SUBJECT: NFPA 1970 (1971) Proposed TIA No. 1594 **FINAL CC BALLOT RESULTS**

NFPA 1971-2018 Edition

Standard on Protective Ensembles for Structural Fire Fighting and Proximity Fire Fighting

TIA Log No.: 1594

Table B.2 Garments.

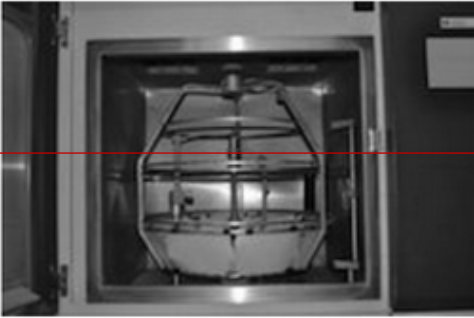
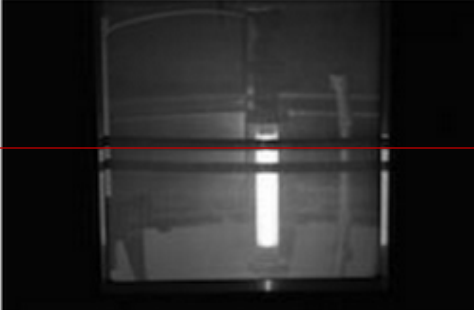
5. Delete the line entry 7.1.23, and photos for “Exterior of Xenon Apparatus” and “Interior of Xenon Apparatus in Use”, and update the cross references in Table B.2 Garments as shown here:
